## MSO9104A-04

**S E R V I C E N O T E**Supersedes:  
None**MSO9104A Oscilloscope: 1 GHz, 4 analog channels**

The 9000 series Infiniium scopes are showing intermittent shutdown symptoms. This service note is providing more information that Service Note - 02A doesn't always complete the repair. This Modification Recommended is to be done on any 9000 scope that is having the cover removed for any reason, and falls into the above serial number range.

Figure #1.

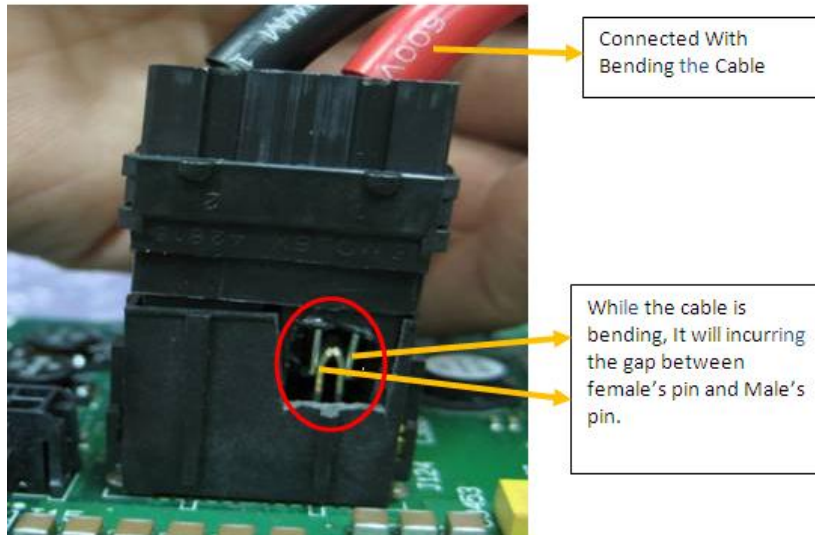
Many customers are experiencing Random Shutdowns. This make them want to have Service Note - 02A completed. The problem is with service note -02A, this isn't the only possible cause for the symptom consequently not resolving their problems. This issue has been determined to be a connection problem with the J124 connector on the acquisition assembly and the 12 volt power cable. See figure #1.

Replace the 12 Volt Bulk power cable to the longer version 54904-61631 eliminating the connector tilt increasing the surface tension. See Figure #2. Clean and inspect the connection J124 on the acquisition board. If the J124 is pitted then replace the acquisition board. Use contact cleaner or alcohol.
